Docket Item #3
BAR CASE # 2017-0106
BAR Meeting
April 26, 2017

ISSUE: Re-approval of a Certificate of Appropriateness for New Construction
APPLICANT: Timothy Kane
LOCATION: 408 North Henry Street
ZONE: RB / Residential

BAR2017-00106

Figure 1: BAR#2014-0020 elevations; approved, with conditions

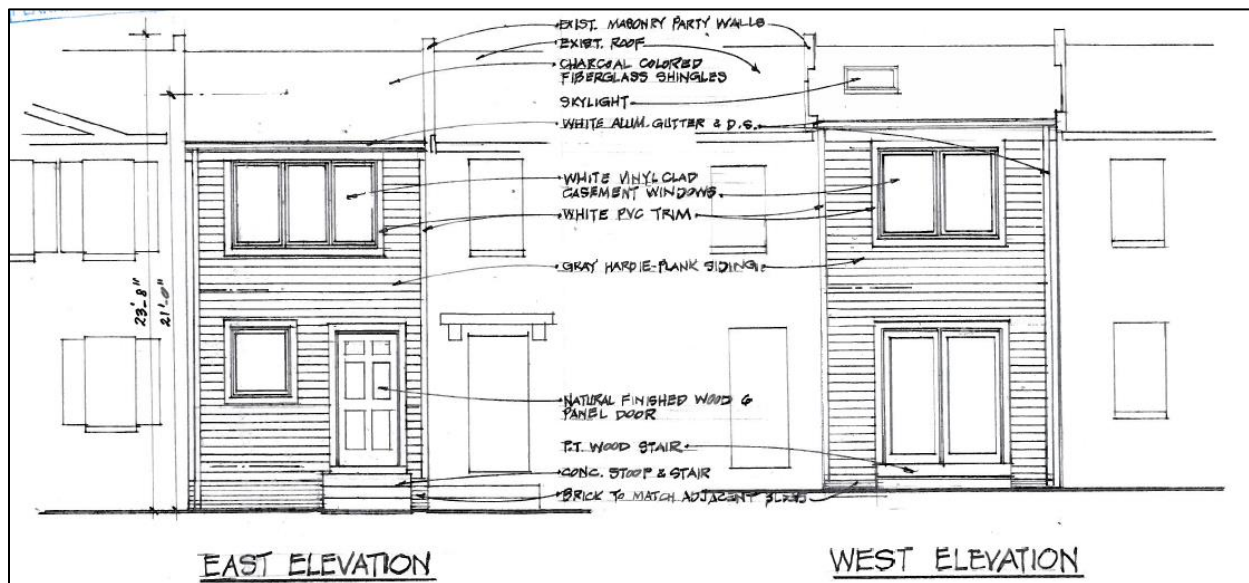
After the BAR approved the new townhouse at 408 North Henry Street in 2014, the prior owner obtained a building permit to construct the house (Figure 1). The building permit plans (Figure 2) integrated the Board's two conditions of approval, but construction was never commenced; both the building permit and the BAR approval have since expired and the new property owner is seeking BAR re-approval for the townhouse.

On March 24, 2014, the Board approved BAR Case #2014-0020 for the construction of a townhouse with the following conditions:

1. The front façade must be brick in a color similar to the adjacent townhouses, with a mortar color that is close in tone to the brick;
2. The applicant must select a more modern front door design; and,
3. The applicant is strongly encouraged to install an optional door hood or awning in a contemporary style.

Figure 2: Approved building permit elevations (BLD2015-0346, 4/8/15); not constructed

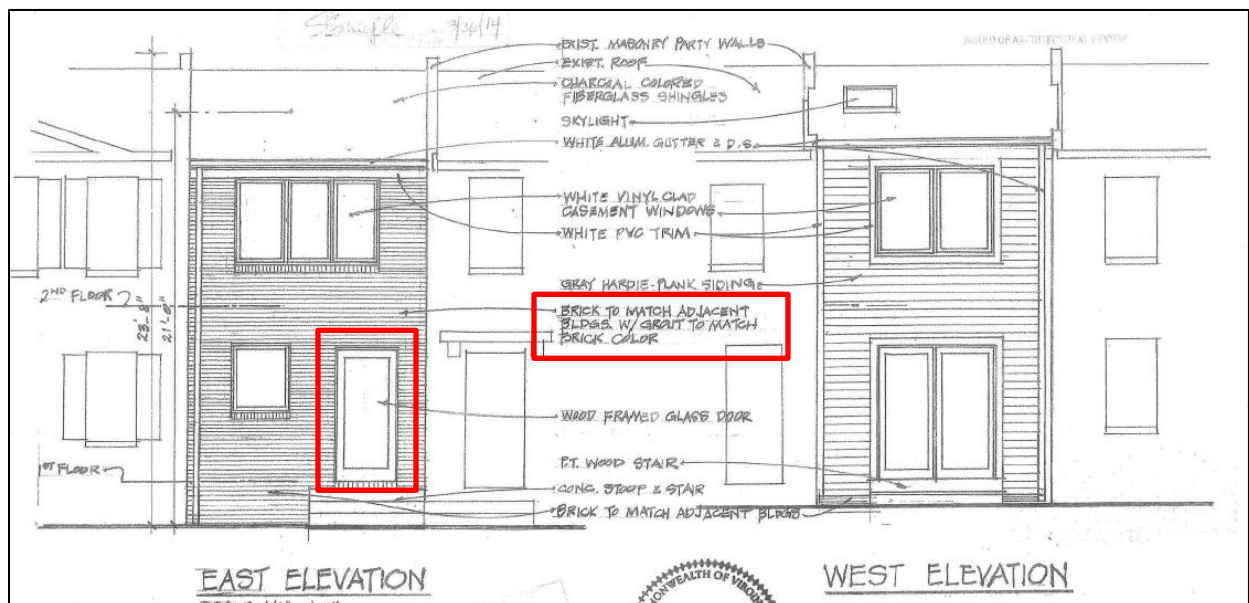
At the hearing, the Board strongly encouraged the applicant to consider the installation of a contemporary door hood or canopy. The other 11 units in this row, with the exception of the two townhouses that have full width front porches, appear to have their original projecting canopies. Although the applicant choose not to install a canopy at the time the building permit was approved, staff continues to support a canopy over the front door. Not only would it help to relate the new townhouse to the existing townhouses in the row, it would also provide some functional relief by provide some protection from the inclement weather and sun (the front of the house faces southeast). As the Board is aware, this is an alteration that is occasionally requested by homeowners who have no protection over their front doors. With that encouragement, Staff recommends approval of the proposed new townhouse.

1. Encourage the addition of a contemporary style door hood or canopy above the front entrance.
2. Include the following archaeology conditions in the General Notes of all site plans and on grading plans so that on-site contractors are aware of the requirements.
